Subject: **Nationwide 23 Permit Modification Application** for the replacement of Bridge Nos. 35 & 44 over Six Runs Creek on NC 403 (Faison Highway), Sampson County. Federal Aid Project No. BRSTP-403(2), State Project No. 8.1281401, Division 3, TIP No. B-3906, WBS #33341.1.1.

Reference: Section 404 Nationwide Permit 23 issued December 17, 2004, USACE Action ID#: 200101309

PROJECT 33341.1.1 (B-3906)  
BRIDGES NO. 35 & NO. 44 ON NC 403 (FAISON HIGHWAY)  
OVER SIX RUNS CREEK

Permit Sheet 5 of 12

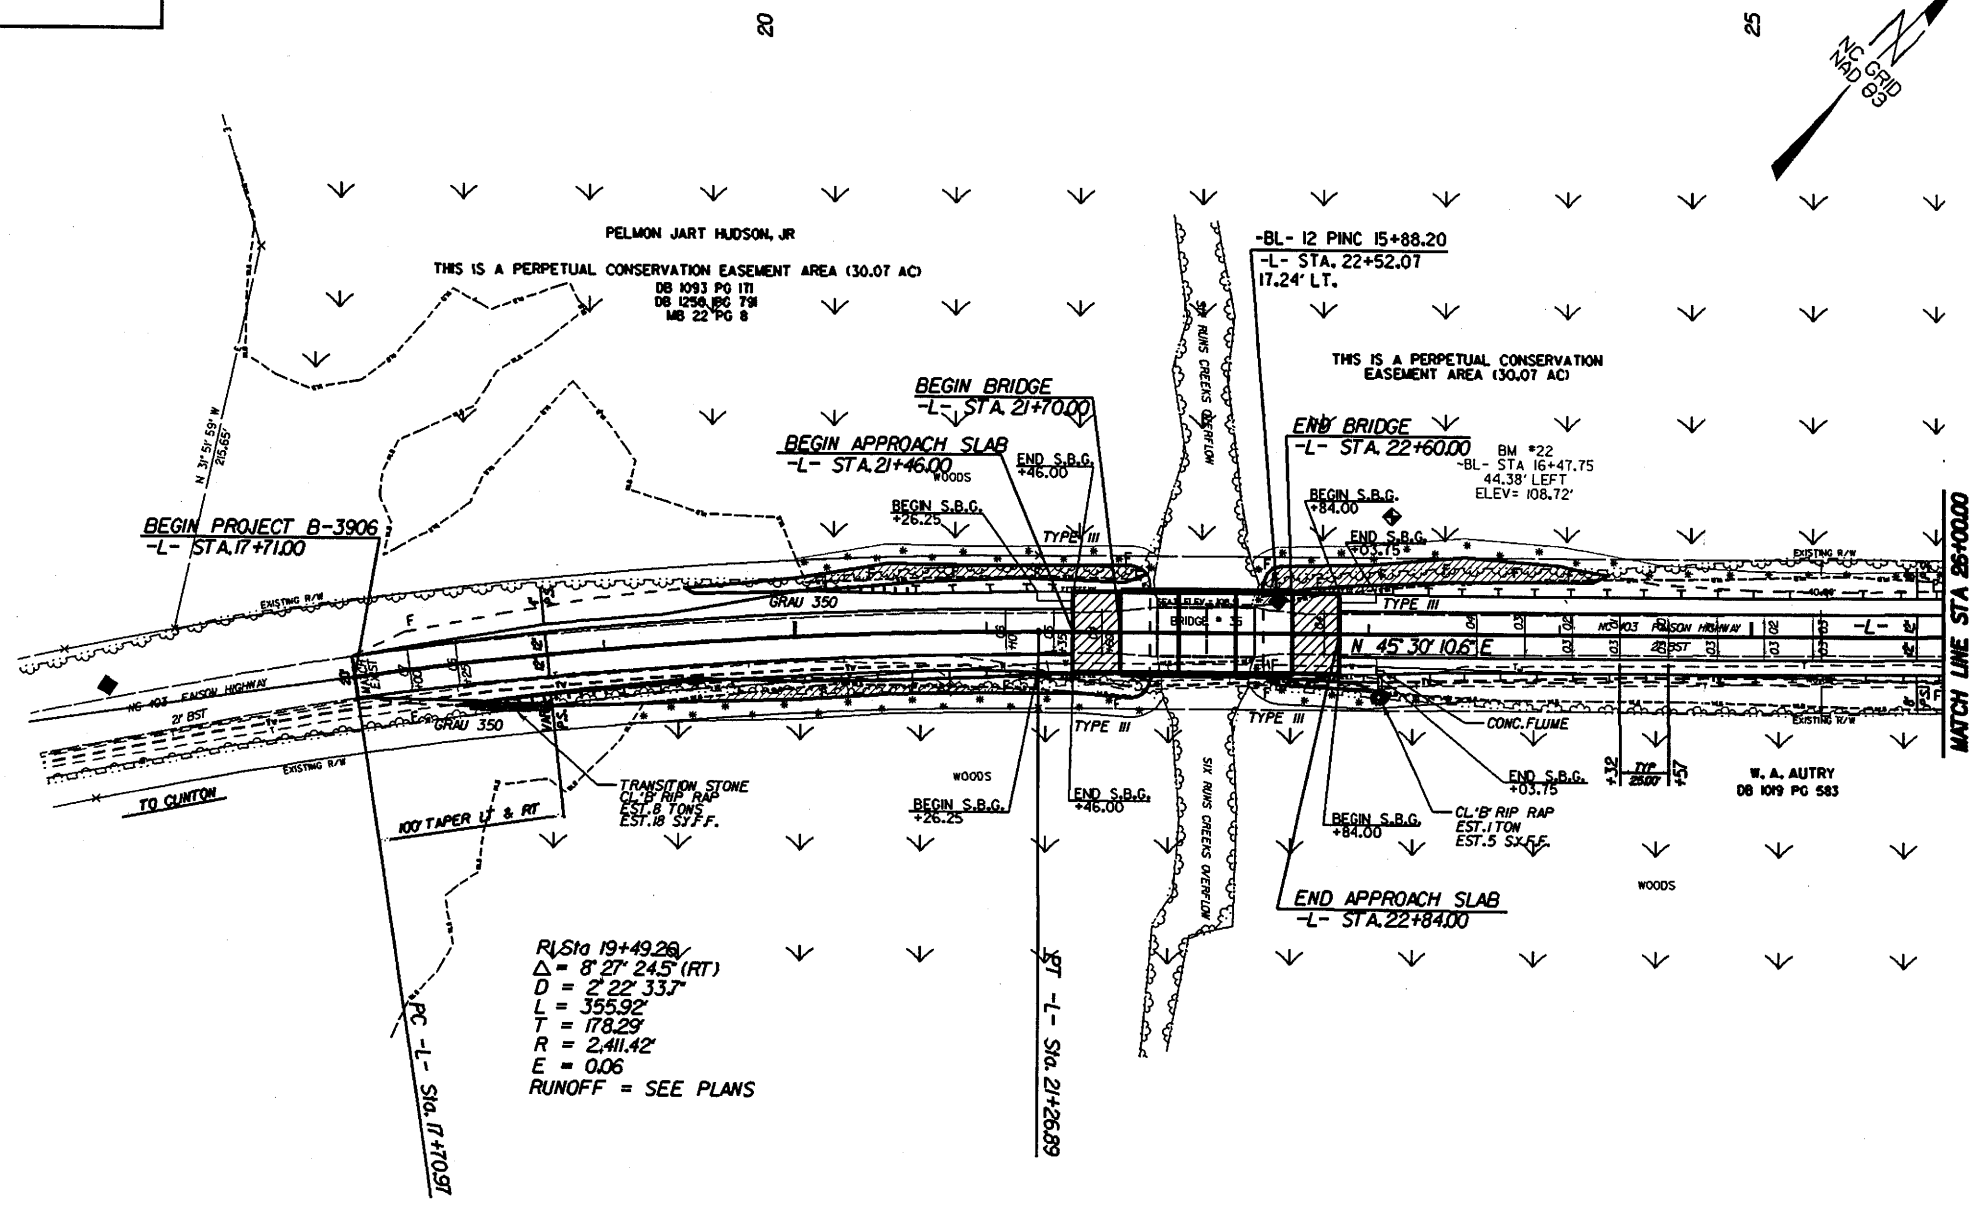
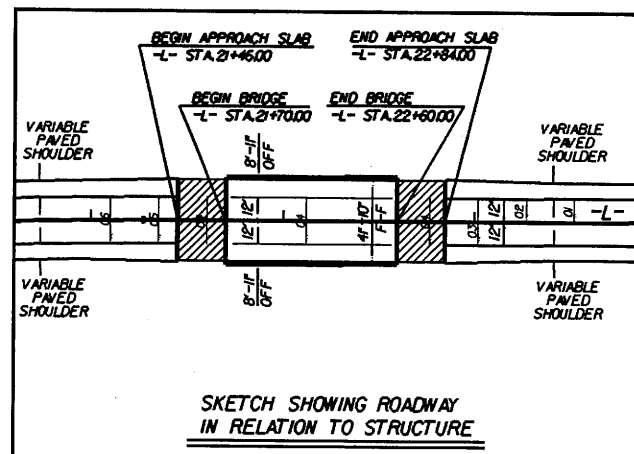
On December 17, 2004 the USACE issued a NWP 23 for the replacement of Bridge Nos. 35 and 44 over Six Runs Creek on NC 403 in Sampson County. Due to oversight on the part of NCDOT the use of bents in the construction of each bridge was not included in the original permit drawings and was not documented in the original permit application. The purpose of this letter is to request a modification to the original permit and include the construction of bents in Six Runs Creek for the construction of both Bridge No. 35 and 44. The revised sheets of the original permit drawings are attached.

Permanent impacts resulting from the placement of two bents in Six Runs Creek for each bridge is 0.002 acre per bridge for a total of 0.004 acre. NCDOT is not proposing additional mitigation for these impacts.
